Access Compliance Report

Public Rights-of-Way

(Curb Ramps)

Intersection ID: 8380	Main Street: CENTRE_ST	Cross Street: TENNESSEE_AV	Location: S
ADA ID: EF211344EE9B	Ramp Type: Perp	Initial Pass/Fail: Fail	Overall Compliance: No
		Severity Score: 8.75

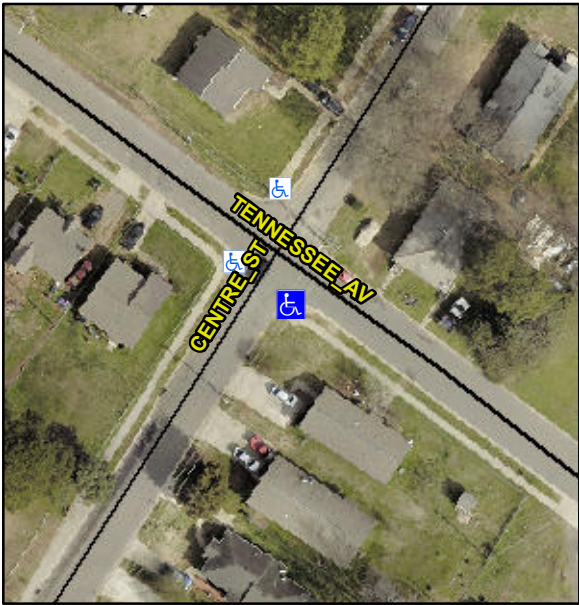
Codes/Mitigation Info/Possible Solution				Field Measurements/Component Compliance					
	Possible Solutions:			Compliance	Description	Data	Compliance	Description	Data
	Remove & Replace Entire Ramp.			N/A	Ramp Length (in)	59.0	Yes	Ramp Slope (%)	5.2
				No	Ramp Width (in)	46.5	Yes	Ramp XSlope (%)	0.4
				N/A	Flare Type LT	N/A	N/A	Flare Type RT	N/A
				N/A	Flare Slope LT (%)	N/A	N/A	Flare Slope RT (%)	N/A
				N/A	Flare Traversable LT?	N/A	N/A	Flare Traversable RT?	N/A
				N/A	Landing Length (in)	N/A	N/A	DWS Provided?	N/A
				N/A	Landing Width (in)	N/A	N/A	DWS Contrast?	N/A
				N/A	Landing Slope (%)	N/A	N/A	DWS Length (in)	N/A
				N/A	Landing X Slope (%)	N/A	N/A	DWS Full Width?	N/A
Surveyor Notes:	N/A			N/A	Landing Curb? (Y/N)	N/A	N/A	DWS Offset (in)	N/A
				N/A	Shared Landing?	N/A			
	PROW/ADA:			N/A	Gutter Ponding?	N/A	N/A	Gutter Slope (%)	N/A
	Not Found, R304.5.1			N/A	Gutter Lip Ht (in)	N/A	N/A	Gutter X Slope (%)	N/A

N/A	Painted X Walk1?	No	N/A	Painted X Walk2?	N/A
					X Walk 1 Direction	To NW		X Walk 2 Direction	N/A
				N/A	X Walk 1 Width (in)	N/A	N/A	X Walk 2 Width (in)	N/A
					X Walk 1 Slope (%)	5.8		X Walk 2 Slope (%)	N/A
					X Walk 1 X Slope (%)	3.1		X Walk 2 X Slope (%)	N/A
				N/A	Ramp inside XWalk1?	N/A	N/A	Ramp inside XWalk2?	N/A
				Road Slope (%)	N/A	N/A	Clear Space?	N/A	
				Road X Slope (%)	N/A	N/A	Clear Space to XWalk (in)	N/A	
			N/A	Any Obstructions?	N/A	N/A	Storm Grate/Utility Hazard?	N/A	
				Obstruction Type			Storm Grate/Utility Type		
					N/A			N/A	
						Yes	Surface Condition? (G/P)	Good	
Total Cost:				\$	1850.00
